**Nature of Work: TEAR OFF & REROOF W/PIONEER TILE (7/12 PITCH)**

Eddie Braddock  
7680 River Ranch Way  
95831 TILE ROOF WORKSHEET

re: Job 99289: BRADDOCK

Subject: Structural Investigation Report of the Roof for the Residence located at 7680 River Ranch Way, Sacramento, CA 95831.

**ROOF PLAN - BRADDOCK**

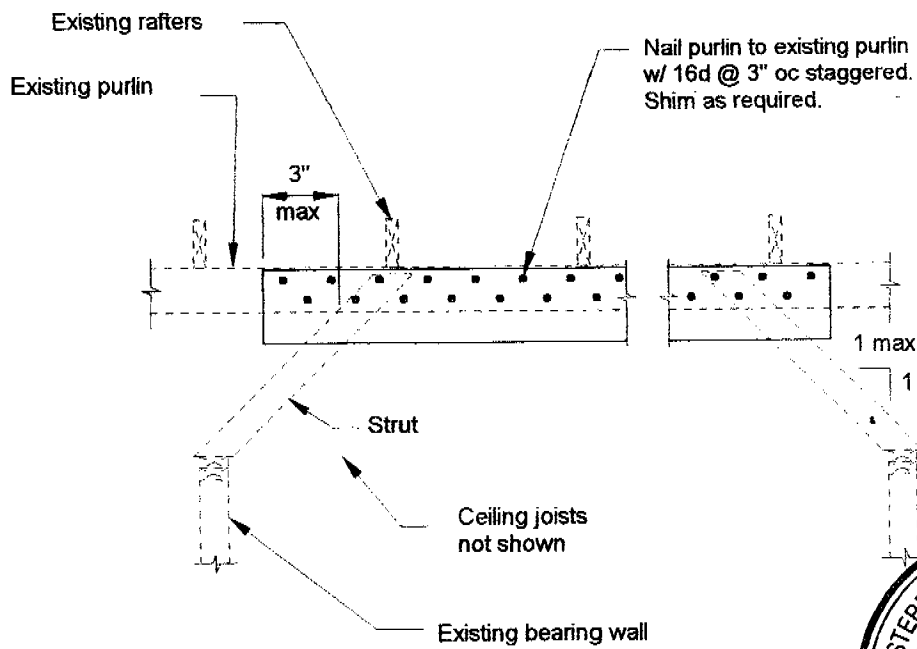
Roof:  
The living and garage areas lack sufficient structural capacity for the applied live and dead loads.

1. Scab a 1 3/4"x14" x 20'-0" long LVL purlin to the existing 2x6 purlin. Attach it with 16d's @ 3" on center. Support the LVL to the bearing walls below with 2x4 struts. See details 1 and 2.
2. Properly install 2x4 struts (or add a 2x4 scab to both the existing purlin and strut) to prevent the purlin from "rocking" off the top of the existing strut. See detail 1.
3. Provide an additional 2x4 strut from the existing purlin to the bearing wall below. The maximum spacing between the new and existing struts shall not exceed 6'-0" on center and the minimum slope of the struts shall not be less than 45 degrees from the horizontal. See detail 1.

4. Scab a 1 3/4" x 11 7/8" microlam beam to the existing header. See details 1 and 3.

### HEADER DETAIL

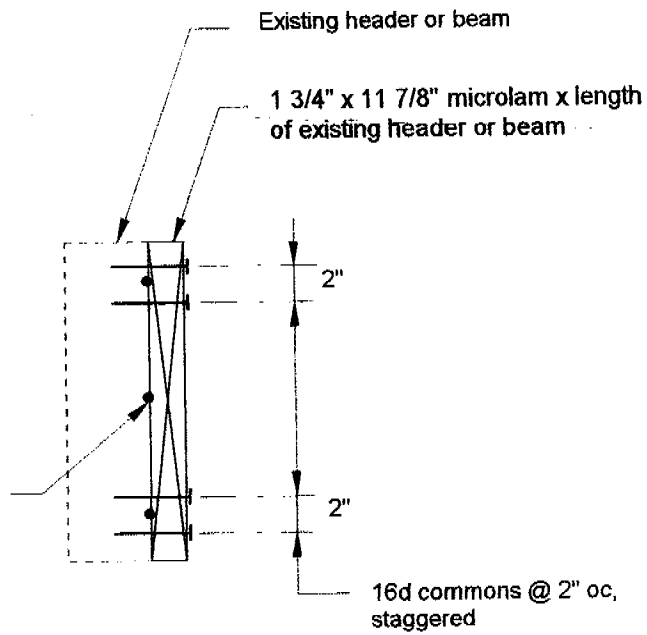
Apply 3 continuous beads (rows) of "Liquid Nail" or equal along length of beams.
